PRODUCT/PROCESS CHANGE NOTIFICATION

PCN MMS-MMY/12/7438
Dated 24 Aug 2012

M95128, 128 Kbit SPI Bus EEPROM / Industrial range
Redesign and upgrade to the CMOSF8H process technology

Figure 20. UFDFPN8 (MLP8) - 8-lead ultra thin fine pitch dual flat no lead, package outline

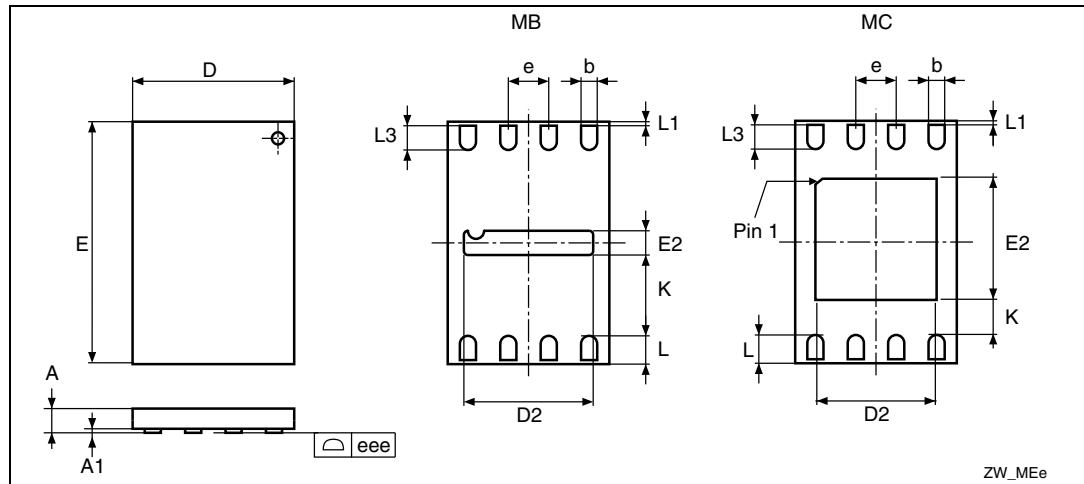
- SO8N (Narrow, 150 mils) assembled on SHD line at ST Shenzhen will use 0.8 mil Copper wire (as introduced in PCN MMS-MMY/11/6929).
- MLP 2x3 (UFDFPN) will change from small exposed pad (package code "MB") to large exposed pad (package code "MC"), PTN will be released in 2h/2012.
